Access Compliance Report

Public Rights-of-Way

(Curb Ramps)

Intersection ID: 10832	Main Street: E_27TH_ST	Cross Street: YADKIN_AV	Location:	N
ADA ID: 316FC6EA0337	Ramp Type: BlendTrans1	Initial Pass/Fail: Fail	Overall Compliance: No	Severity Score: 10
Codes/Mitigation Info/Possible Solution		Field Measurements/Component Compliance

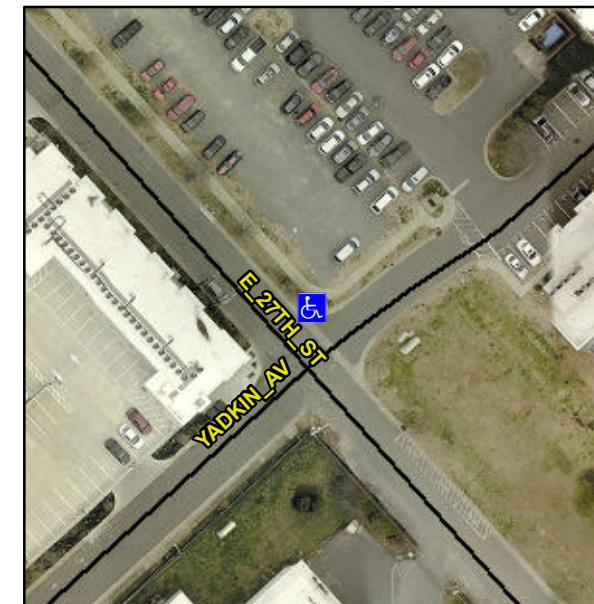
Not Found, R304.5.1, R304.5.3

Compliance	Description	Data	Compliance	Description	Data
N/A	Ramp Length (in)	90.5	Yes	BlendTrans Slope (%)	4.8
No	Ramp Width (in)	47.0	No	BlendTrans XSlope (%)	2.9
N/A	Flare Type LT	N/A	N/A	Flare Type RT	N/A
N/A	Flare Slope LT (%)	N/A	N/A	Flare Slope RT (%)	N/A
N/A	Flare Traversable LT?	N/A	N/A	Flare Traversable RT?	N/A
N/A	Landing Length (in)	N/A	N/A	DWS Provided?	N/A
N/A	Landing Width (in)	N/A	N/A	DWS Contrast?	N/A
N/A	Landing Slope (%)	N/A	N/A	DWS Length (in)	N/A
N/A	Landing X Slope (%)	N/A	N/A	DWS Full Width?	N/A
N/A	Landing Curb? (Y/N)	N/A	N/A	DWS Offset (in)	N/A
N/A	Shared Landing?	N/A			
N/A	Gutter Ponding?	N/A	N/A	Gutter Slope (%)	N/A
N/A	Gutter Lip Ht (in)	N/A	N/A	Gutter X Slope (%)	N/A
N/A	Painted X Walk1?	No	N/A	Painted X Walk2?	No
	X Walk 1 Direction	To SW		X Walk 2 Direction	To SE
	X Walk 1 Width (in)	N/A		X Walk 2 Width (in)	N/A
	X Walk 1 Slope (%)	N/A		X Walk 2 Slope (%)	N/A
	X Walk 1 X Slope (%)	N/A		X Walk 2 X Slope (%)	N/A

N/A	Ramp inside XWalk1?	N/A	N/A	Ramp inside XWalk2?	N/A
	Road Slope (%)	3.6		Clear Space?	N/A
	Road X Slope (%)	3.9	N/A	Clear Space to XWalk (in)	N/A
N/A	Any Obstructions?	N/A	N/A	Storm Grate/Utility Hazard?	N/A
	Obstruction Type			Storm Grate/Utility Type	
		N/A			N/A
			Yes	Surface Condition? (G/P)	Good
			No	Curb Slope (%)	16.2

Remove & Replace Curb Ramp With Two New Directional Ramps or Equivalent.
